HIAL Consultation Report

Proposal for the Introduction of Controlled Airspace and Optimisation of Instrument Flight Procedures at Inverness Airport

Consultation Report

Prepared for: Highlands and Islands Airports Limited (HIAL)
Contract Number: HIAL841
Sponsor Consultation Document

Figure 4 The Consulted Inverness Airport CTR and CTAs. Ordnance Survey Digital Data © Crown Copyright 2014, Licence 0100031673

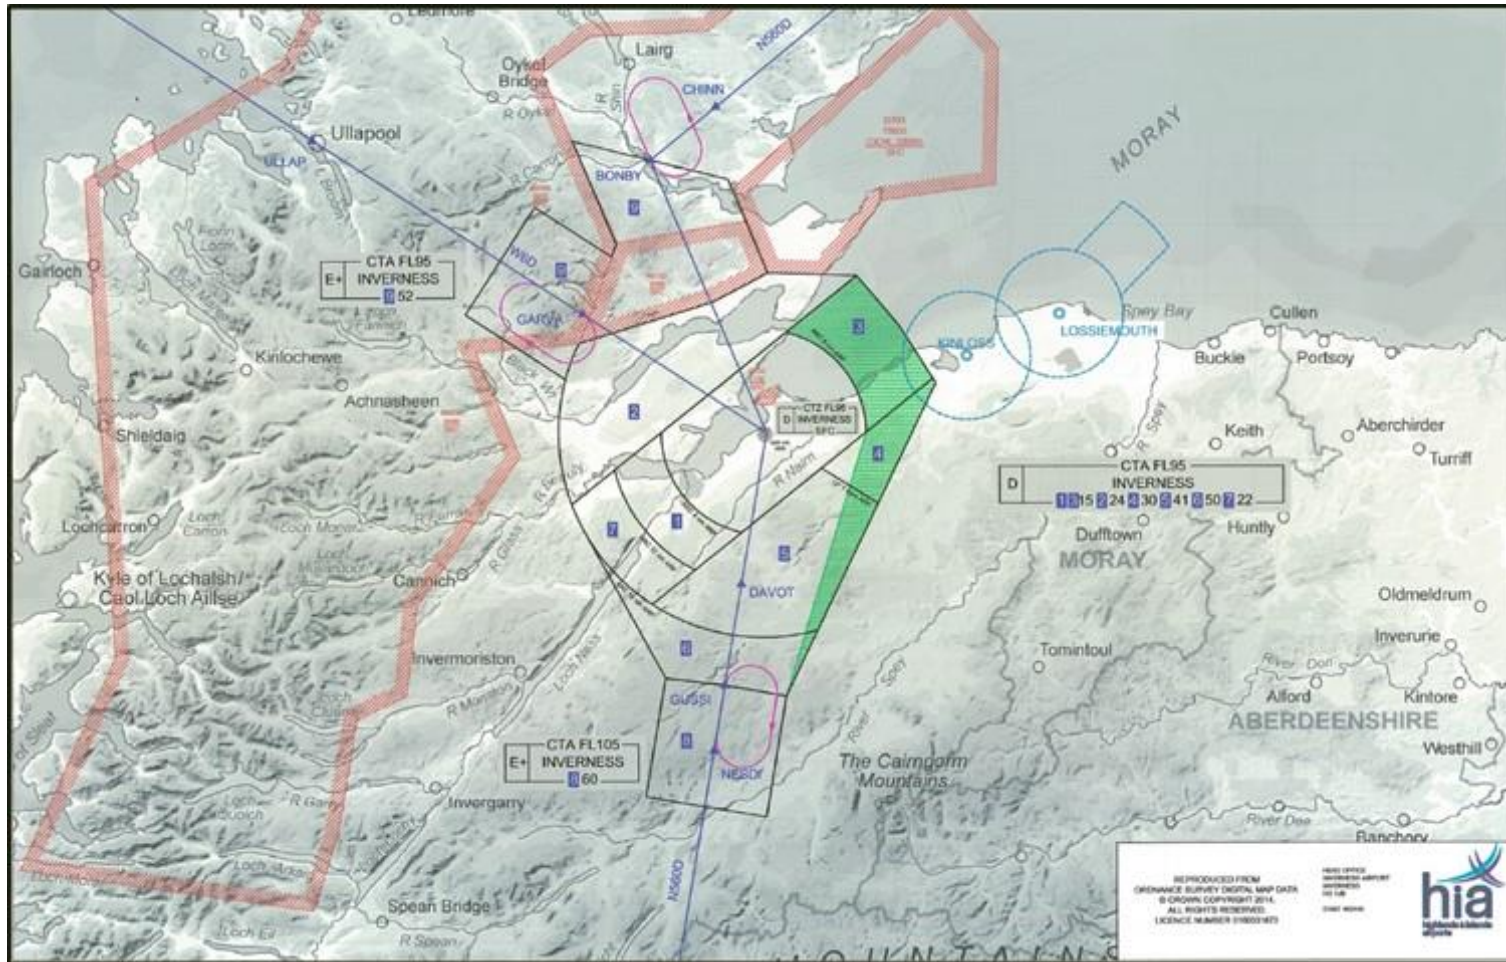
CTA Reference	Nature of Issue	Number of Consultees who Raised Issue	HIAL Proposed Solution or Redesign
CTA-2	CTA-2 will severely impact general handling flying out of Inverness & Dornoch	1	CTA-2 was initially classed as Class D airspace. A change of classification to Class E airspace (with the inclusion, within the same volume, of transponder carriage requirements; Class E + Transponder Mandatory Zone (TMZ)) would mitigate GA VFR concerns in the Black Isle and Dornoch area.
CTA-3	To the East, CTA-3 encroaches the Kinloss Military Air Traffic Zone (MATZ) creating further problems for a non-radio equipped aircraft	1	The encroachment is by approximately 1 NM, which is viewed as a small imposition. Military and Moray Flying Club operations within the Kinloss MATZ are of greater concern. It is anticipated that these operations can be facilitated through a robust Letter of Agreement (LoA) with RAF Lossiemouth (the Tripartite LoA including Tain Range).

CTA-4, CTA-5	CTA-4 and CTA-5 will act as a barrier to gliding activity below Flight Level (FL) 95 (climbing above this level would require an oxygen system)	2	The maximum altitude of Inverness Class D is capped at 5,500 ft or FL 55. The airspace above would become Class E+TMZ. This does not totally mitigate the impact on non-radio equipped gliders; however, it is anticipated that these operations can be facilitated through a robust LoA with Feshiebridge or the BGA.
	Insufficient height above terrain within CTA-4 and CTA-5 to soar a glider	1	The airspace above 5,500 ft or FL 55 would become Class E+TMZ. This does not totally mitigate the impact on non-radio equipped gliders; however, it is

Concern regarding the CTA-8 and its proposed base of 6000 ft above mean sea level (amsl) – only a small proportion of gliders are equipped with transponders and the VHF transmission range will be near or beyond its useful range, so most glider pilots will have difficulty contacting Inverness ATC for clearance to enter CTA-8	1	The objector proposed that consideration should be given to raising the base altitude in this area. However, the base altitude is pre-determined by the procedure profile and ‘containment’ requirements, within CAS, for a procedure. The procedures are in draft form at the time of writing and where possible the base altitude will be raised. However, with both CTAs-8 and 6 as Class E+TMZ, it is anticipated that glider operations can be facilitated through an extension to the current ‘GUSSE Box’ NATS, Inverness & BGA LoA.
	Concern CTA-8 overhead RSPB Insh March Bird Sanctuary, a large sanctuary for nesting birds and forming the Spey Valley route for migrating geese	1	The objector proposed that the CTA-8 is moved to the West. However, it appears that the objector did not understand that CAT operating in and out of Inverness Airport currently use that airspace to access airway N560.

The MOD objects to the current Inverness ACP; it questions the requirement for CTA-2 and CTA-9 given the scale of commercial operations utilising the associated Class E airways structure.

The MOD seeks further clarification on the requirement for the dimensions of CTA-3 and CTA-4 given their encroachment into the Kinloss MATZ. The MOD is not opposed to the concept of Air Traffic Service (ATS) provision by RAF Lossiemouth within the Inverness CTA, but requires the CAA to issue policy/approval.

A change of airspace classification for CTA-2 to Class E+TMZ will mitigate base of CAS concerns near Knockbain airstrip and over the Black Isle for VFR operators with a transponder and/or radio. Those with radio only would need to call Inverness ATC relaying their intentions and to build information on any military traffic entering or exiting Tain Range.

A change of airspace classification for CTA-6 to Class E+TMZ will mitigate base of CAS and access concerns near Feshiebridge aerodrome for VFR operators with a transponder, or radio where not equipped with a transponder. An amendment to the
